# Access Compliance Report

## Public Rights-of-Way

### (Curb Ramps)

Intersection ID: 10038266	Main Street: SMITHFIELD_CHURCH_RD	Cross Street: N/A	Location: N
ADA ID: AFCA52BB0EEC	Ramp Type: Perp	Initial Pass/Fail: Fail	Overall Compliance: No
		Severity Score: 12.5

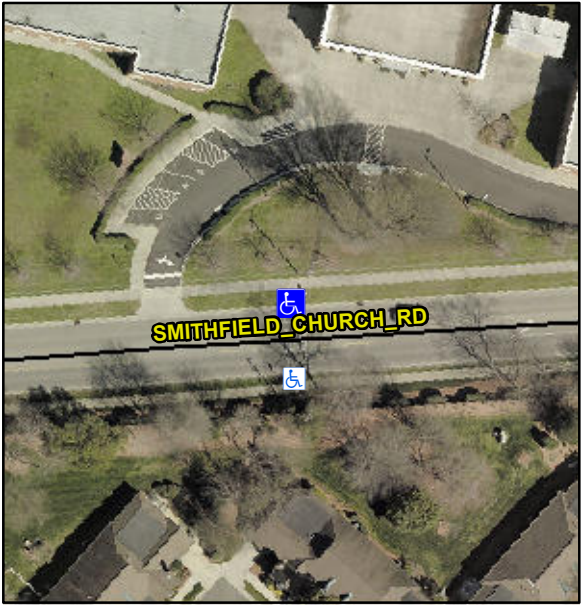
Codes/Mitigation Info/Possible Solution			Field Measurements/Component Compliance		
	Possible Solutions:		<b>Compliance</b>	<b>Description</b>	<b>Data</b>
	Remove & Replace Entire Ramp.		N/A	Ramp Length (in)	96.0
			Yes	Ramp Width (in)	76.0
			N/A	Flare Type LT	N/A
			N/A	Flare Slope LT (%)	N/A
			N/A	Flare Traversable LT?	N/A
			N/A	Landing Length (in)	N/A
			N/A	Landing Width (in)	N/A
			N/A	Landing Slope (%)	N/A
			N/A	Landing X Slope (%)	N/A
<p>Surveyor Notes:</p> <p>N/A</p> <p>PROW/ADA:</p> <p>R304.2.2</p>			N/A	Flare Type RT	N/A
			N/A	Flare Slope RT (%)	N/A
			N/A	Flare Traversable RT?	N/A
			N/A	DWS Provided?	N/A
			N/A	DWS Contrast?	N/A
			N/A	DWS Length (in)	N/A
			N/A	DWS Full Width?	N/A
			N/A	DWS Offset (in)	N/A
			N/A	Shared Landing?	N/A
			N/A	Gutter Ponding?	N/A
			N/A	Gutter Lip Ht (in)	N/A
			N/A	Painted X Walk1?	Yes
				X Walk 1 Direction	To S
			N/A	X Walk 1 Width (in)	110.0
				X Walk 1 Slope (%)	3.8

X Walk 1 X Slope (%)	0.5
			N/A	Ramp inside XWalk1?	Yes
			N/A	Road Slope (%)	N/A
			N/A	Road X Slope (%)	N/A
			N/A	Any Obstructions?	N/A
				Obstruction Type	
Total Cost:		\$ 1850.00			
			N/A		N/A
			Yes	Surface Condition? (G/P)	Good
